WH179 January 2023

Appendix A: Schedule of Changes to Drawings

Schedule of changes to drawings - Rev A to Rev C

Anglia Square Rev A - Rev C Supporting Information

Masterplan L00 Rev C

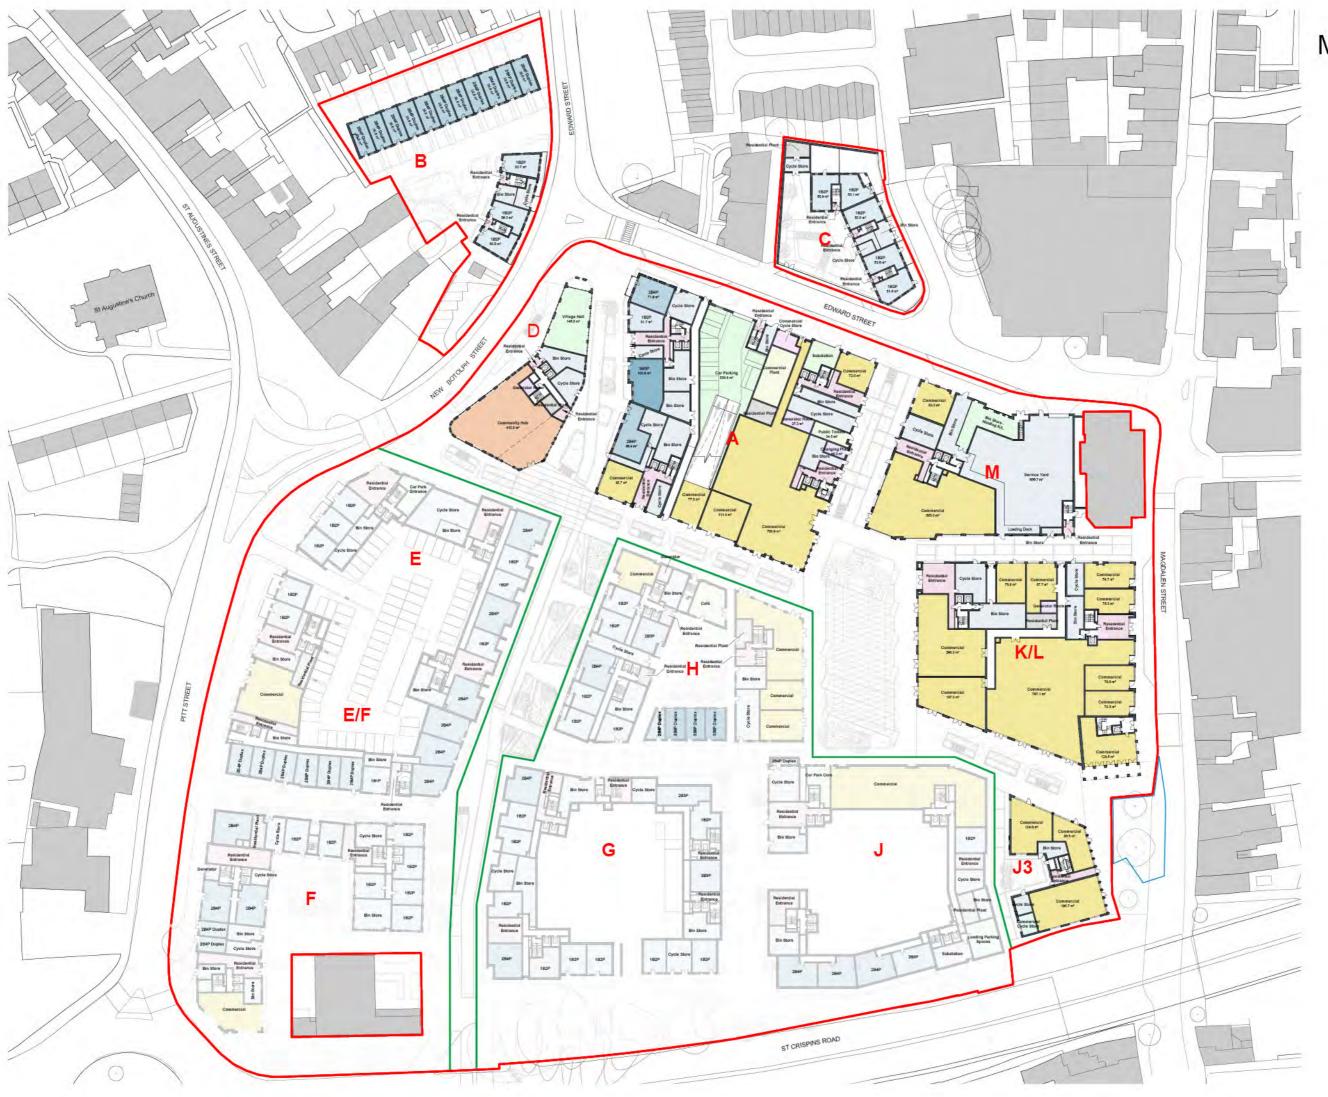
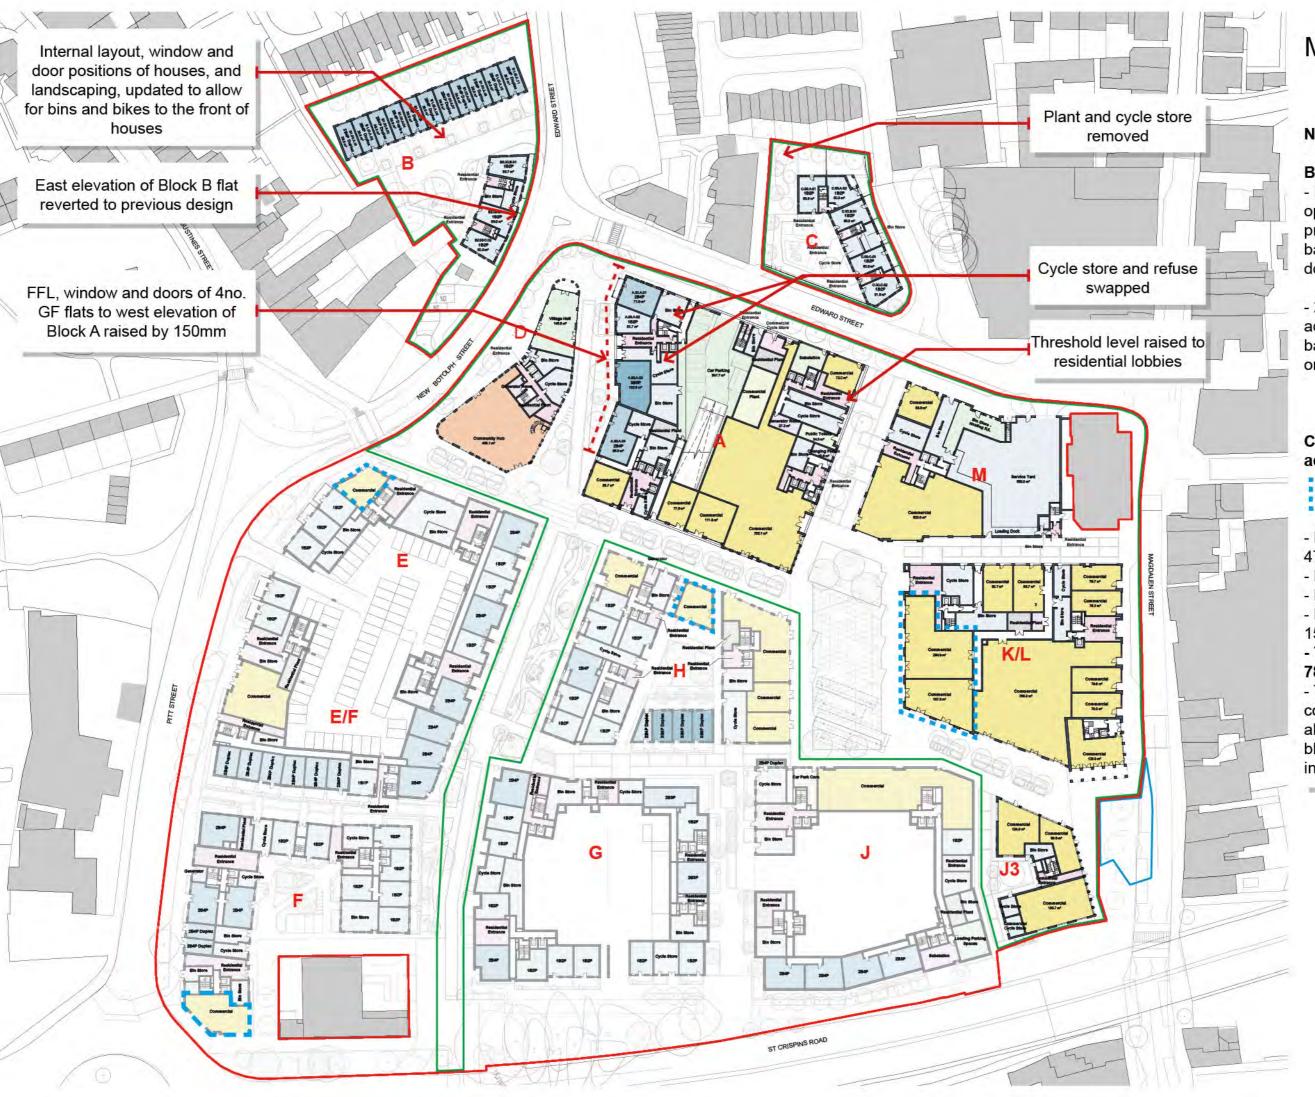
Block A

- Direct access to the open air for all stairs that provide escape from the basement, with external doors added.
- 2no. lifts have been added that serve the basement to ground floor only.

Commercial sqm (NIA) added:

- Block K/L mezzanine: 477.6 sqm
- Block E: 77.7 sqm
- Block H: 79.1 sqm
- Block F mezzanine: 153.2 sqm
- Total additional area:787.6 sqm
- Total long stay commercial cycles allowed for in detailed blocks to accommodate increase: 58

Block A - West Elevation

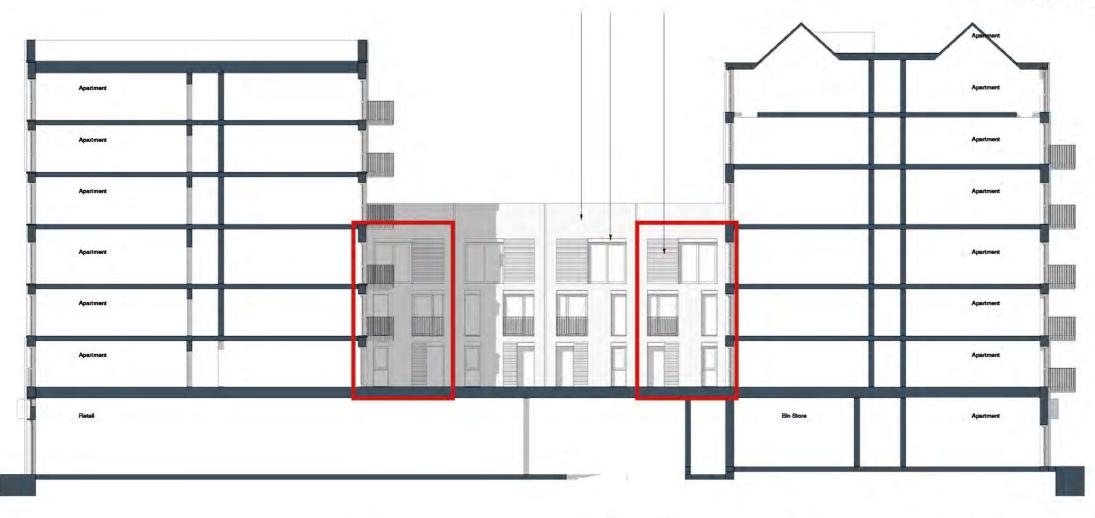
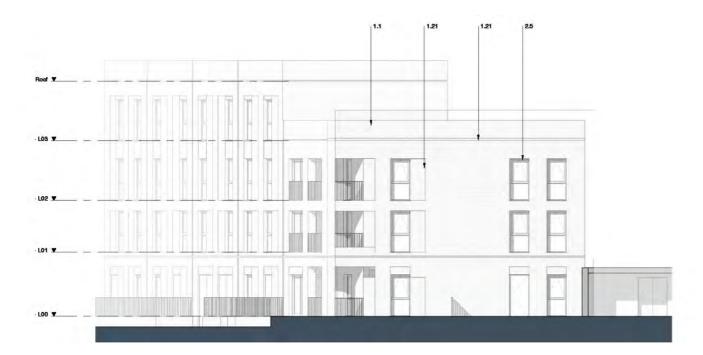
No.	Amendment	Plan / Document Updated
	BLOCK A (Detailed Element)	
1	66 of 91 units tested for daylight and sunlight have had internal layouts amended. 18no. of those units have also had external changes, involving windows adjusted / balconies repositioned or moved.	Masterplans: 35301-ZZ-00-DR-A-01-0099 - 35301-ZZ-00-DR-A-01-0199 GA Plans: 35301-ZA-00-DR-A-03-0099 - 35301-ZZ-00-DR-A-03-0107 Elevations: 35301-ZA-00-DR-A-05-0300 - 35301-ZA-00-DR-A-05-0307 Internal Daylight, Sunlight & Overshaddowing Report
3	66 units re-lested with amendments to internal layout / window / balcony, as above. Ground floor internal cycle store and refuse store swapped positions to allow refuse strategy to comply with NCC standards	Internal Daylight, Sunlight & Overshaddowing Report Masterplans: 35301-ZZ-00-DR-A-01-0100 GA Plans: 35301-ZA-00-DR-A-03-0100 Refuse Strategy
4	Residential lobbies on north and east of Block A ground floor to have threshold level raised / entry hump added to assist with flood strategy	Flood Risk Assessment

Block M - South Elevation

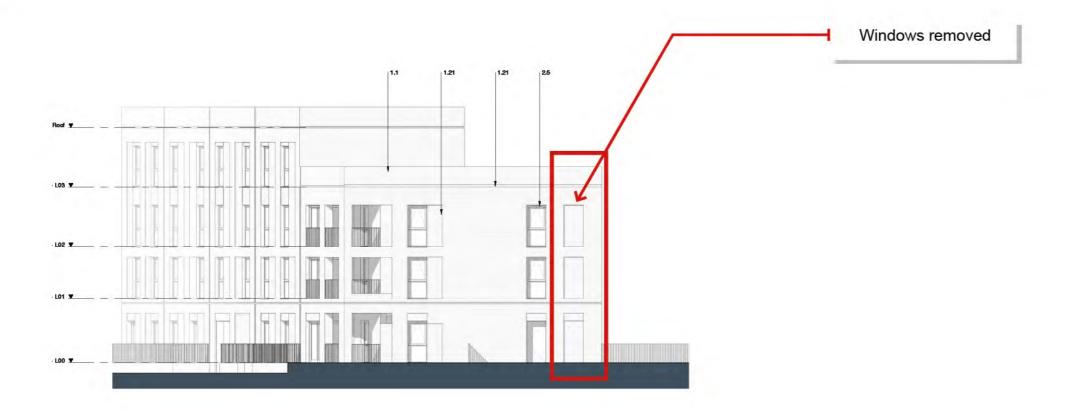
34	11 x units daylight re-tested with amendments to internal layout / window / balcony 3 x units balconies on south elevation re-positioned westward one spening along, Balcony remains off living room area, the larger door opening and smaller window opening off living room repositioned to facilitate balcony move. Those units and below to have daylight re-tested	Internal Daylight, Sunlight & Overshaddowing Report Masterplans: 35301-2Z-00-DR-A-01-0100 - 35301-2Z-00-DR-A-01-0106 GA Plans: 35301-2Z-00-DR-A-03-0100 - 35301-2Z-00-DR-A-03-0106 Elevations: 35301-2M-XX-DR-A-03-0300 Internal Daylight, Sunlight & Overshaddowing Report
36	Pagoda, seating & planting on level 6 terrace coordinated with internal layouts and window positions	Masterplans: 35301-ZZ-00-DR-A-01-0106 GA Plans: 35301-ZM-00-DR-A-03-0106 Landscape Strategy Addendum Landscape Masterplan- ANG-PLA-XX-XX-DR-L-0001 Hardworks Sitle Plan - ANG-PLA-XX-XX-DR-L-1001 Softworks Sitle Plan - ANG-PLA-XX-XX-DR-L-2001
